Corrigendum - II dated 18/06/2026 to CPC Tender No. BHEL/CPC/KRD/EPC LHP GHP/27/023

Corrigendum - II dated 18/06/2026 to CPC Tender No. BHEL/CPC/KRD/EPC_LHP_GHP/27/023 for the work of “EPC PACKAGE FOR LIME HANDLING PLANT, GYPSUM HANDLING PLANT AND BOTTOM ASH HOPPER AT 2X660 MW, MSPGCL KORADI THERMAL POWER STATION, UNIT-11& 12, KORADI, NAGPUR, MAHARASHTRA.”

A) Modification in TECHNICAL CONDITIONS OF CONTRACT (TCC): The following clause of existing TCC are revised as below;

Annexure-20 to TCC - GA Drawing of Day Silo

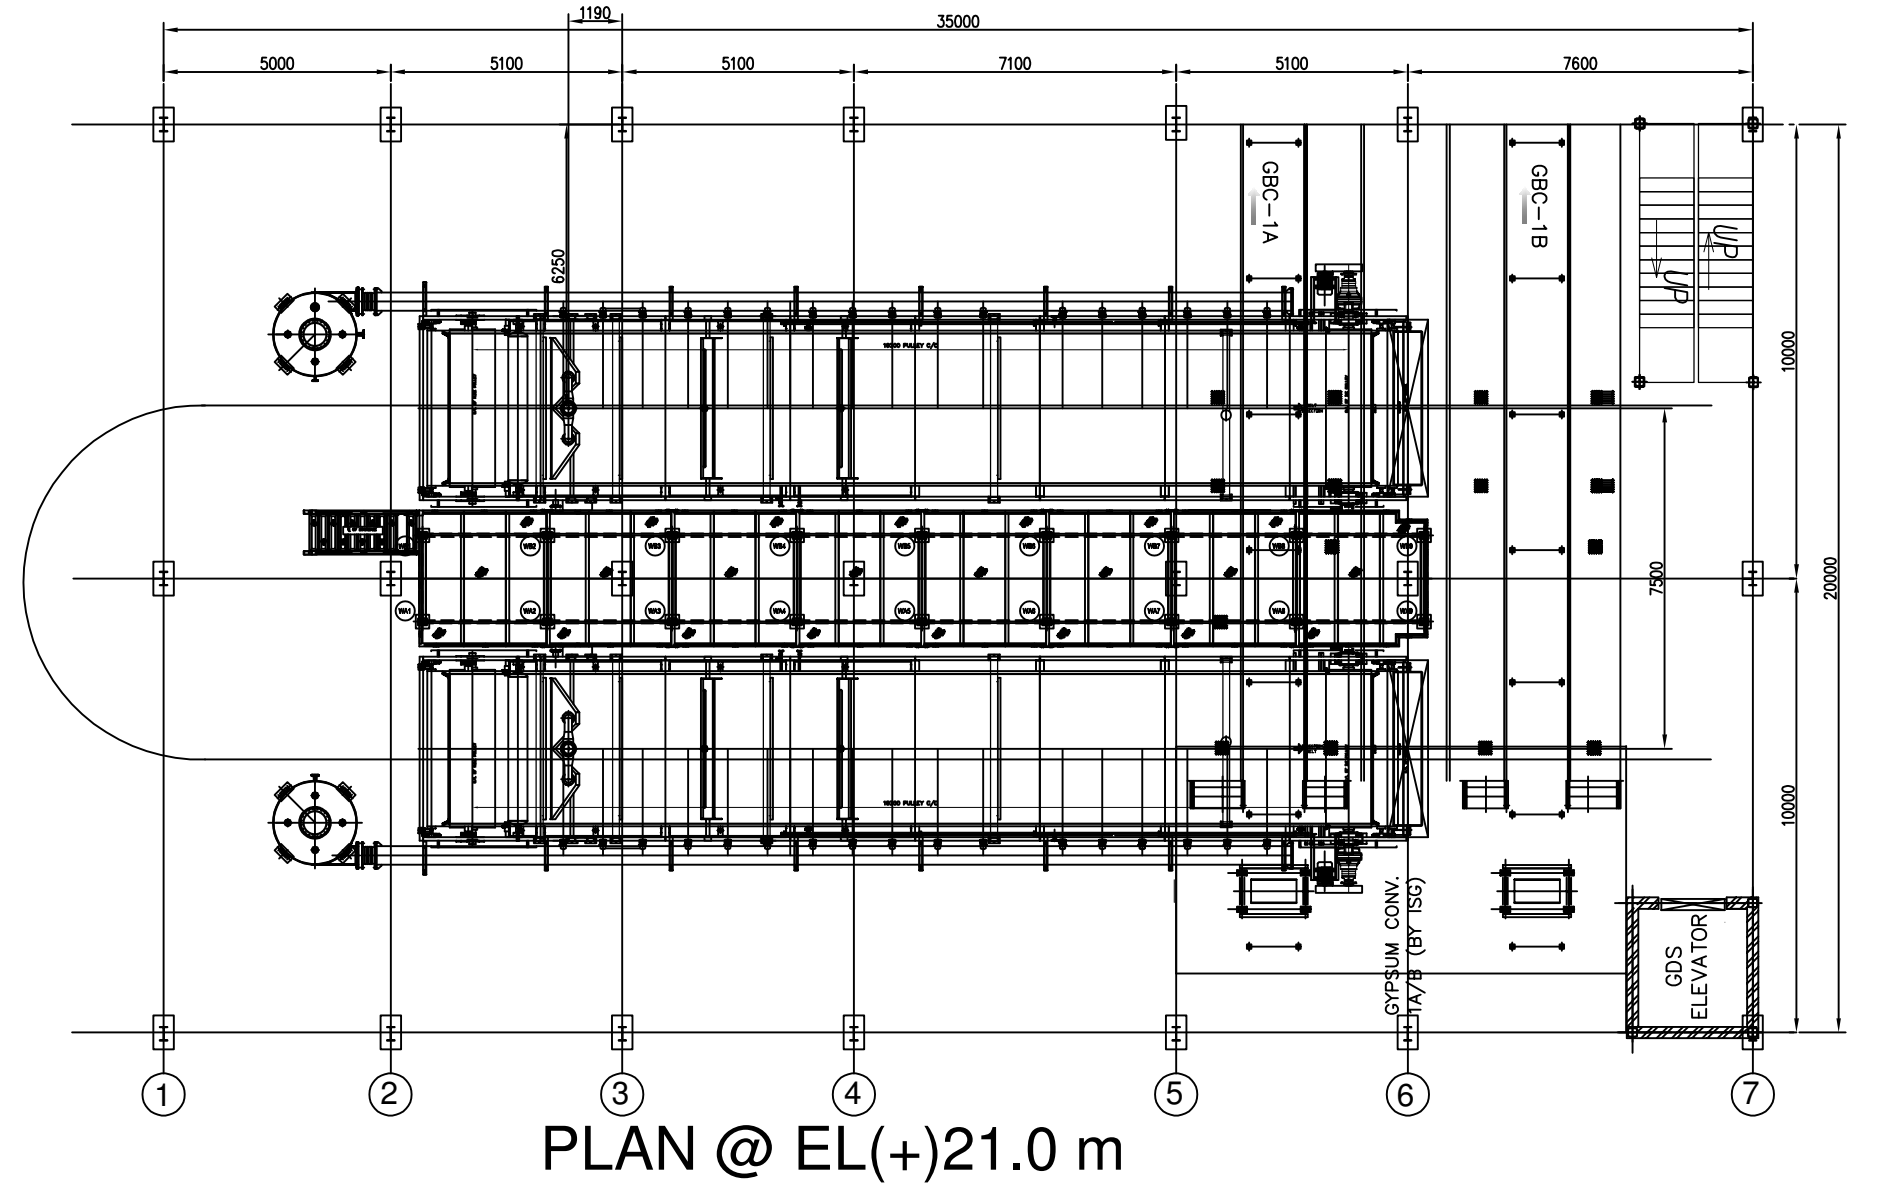
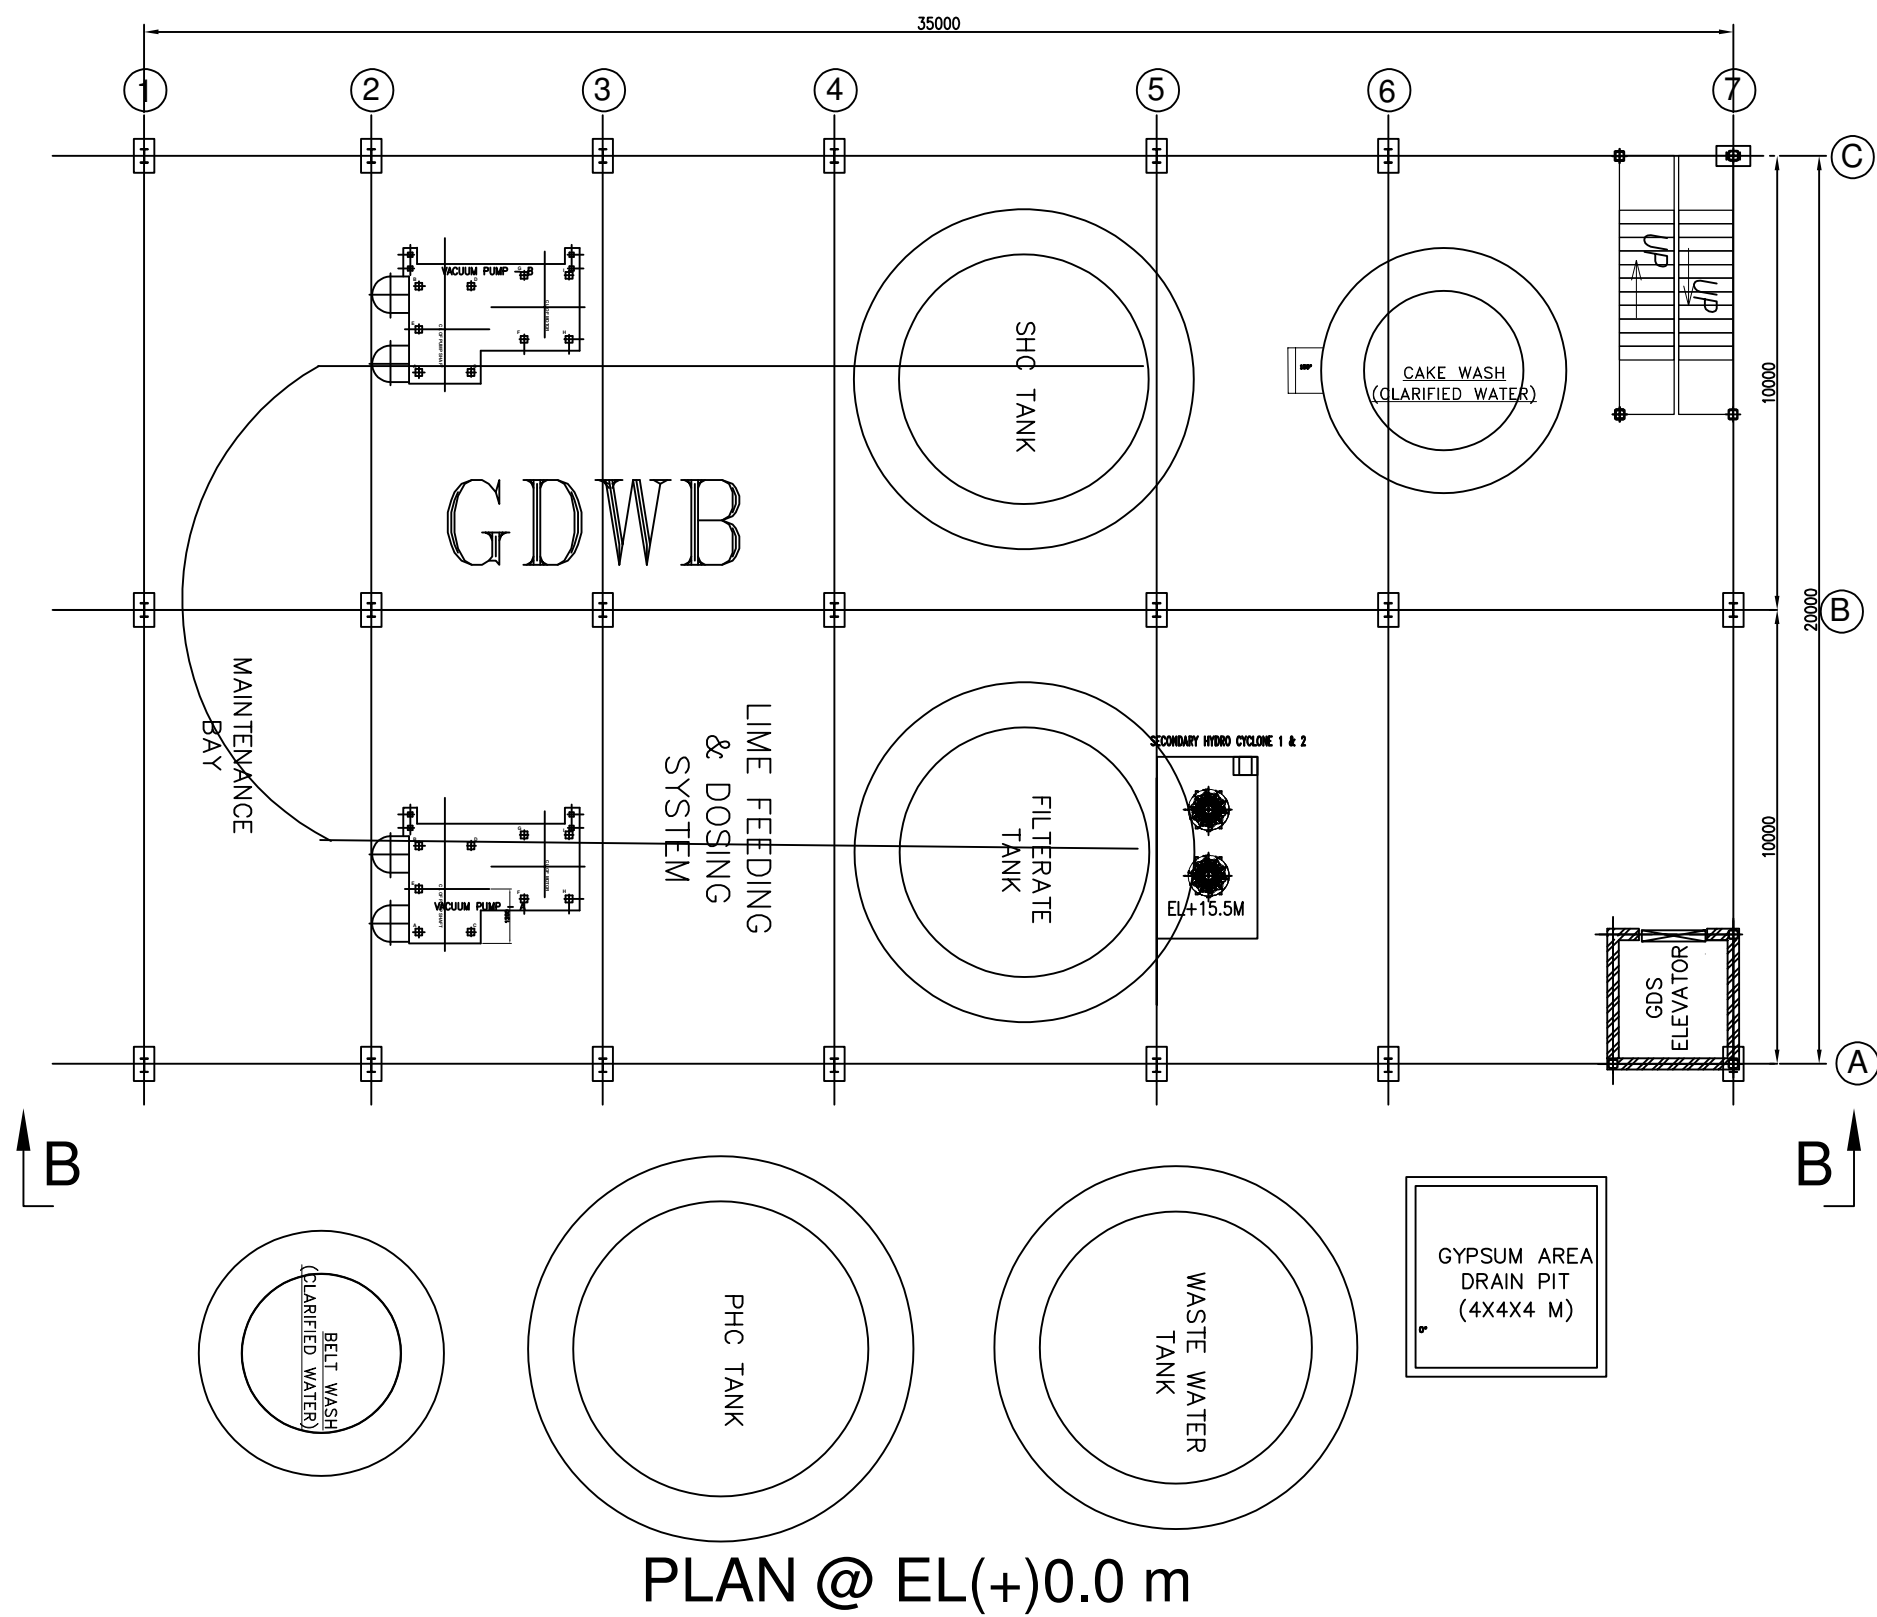
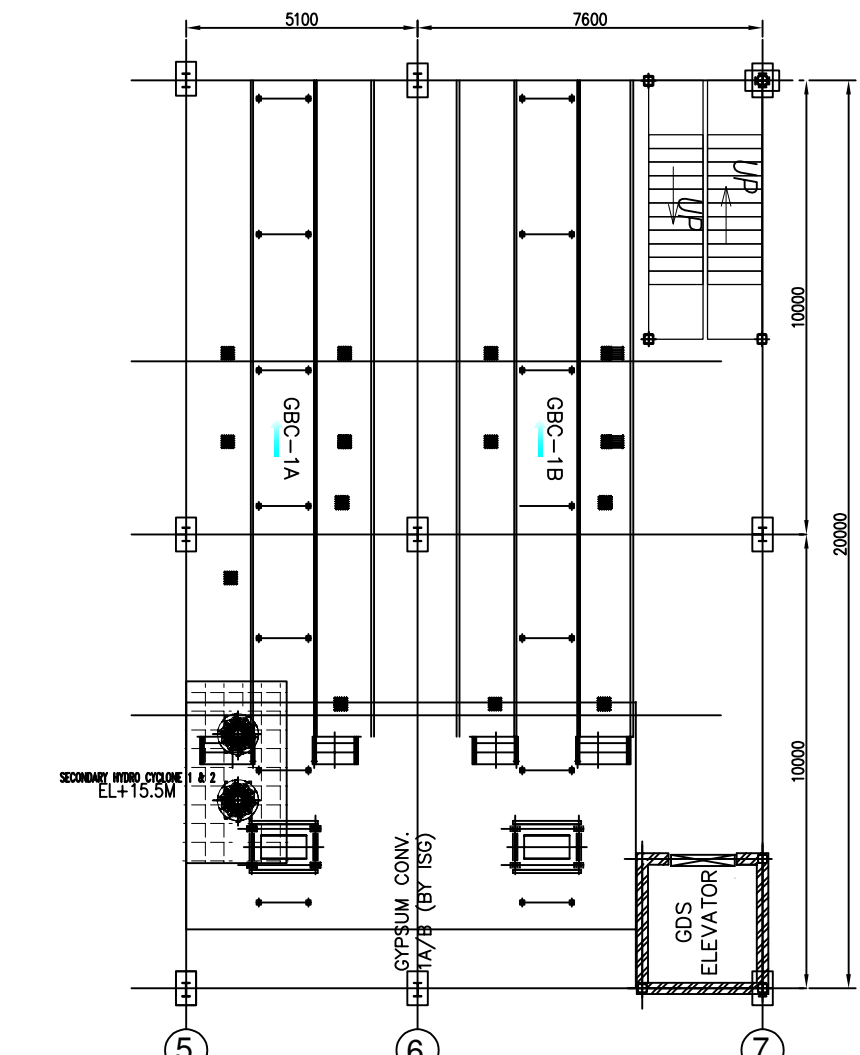
25	—	—	Kindly provide the elevation drawings of the LHS. If the preparation of the elevation layout drawing is within our scope, kindly provide the silo building drawing, including the top-of-silo dimensions and center-to-center (C/C) distances between the silos, to enable us to determine the lengths of RBC-01 and RBC-02.	Developing general arrangement drawings for various facilities is in the scope of bidder. Accordingly, bidder to design & develop GA drawings during detail engineering in line with plot plan, flow diagram, tender specification and amendments & clarification issued till placement of order. Center-to-center (C/C) distance between Silos: 17000mm; Elevation of Floor above Silo: 41 mtr Please refer Annexure-20: GA Drawing of Day Silo as issued in sl. no. A).3 of Modification in TECHNICAL CONDITIONS OF CONTRACT (TCC) above.

Sl. No.	TCC Reference Clause No. / Annexure	Existing clause in Tender	Revised clause		
1	TCC, Annexure-4	Annexure-4-of TCC - Flow Diagram & Bottom Ash Hopper spec & Plot plan (Page no. 1 & 2 – Flow Diagram of LHP & GHP)	1	Rated/design capacity of limestone handling plant	Bidder to note that rated/design capacity of Limestone handling plant shall be 150/165 TPH. Accordingly, capacity & parameters of all equipment shall be considered.
			2	Rated/design capacity of Gypsum handling plant	Bidder to note that rated/design capacity of Gypsum handling plant shall be 50/55 TPH. Accordingly, capacity & parameters of all equipment shall be considered.
2	TCC, Annexure-4	Page no 10/11- Plot Plan - Annexure-4-of TCC - Flow Diagram & Bottom Ash Hopper spec & Plot plan	Revised Plot Plan dated 10.06.2026. (Page no 10/11) of Annexure-4-of TCC is attached with this corrigendum.		
3	TCC, Annexure-20	New Annexure to TCC	Annexure-20 to TCC - GA Drawing of Day Silo
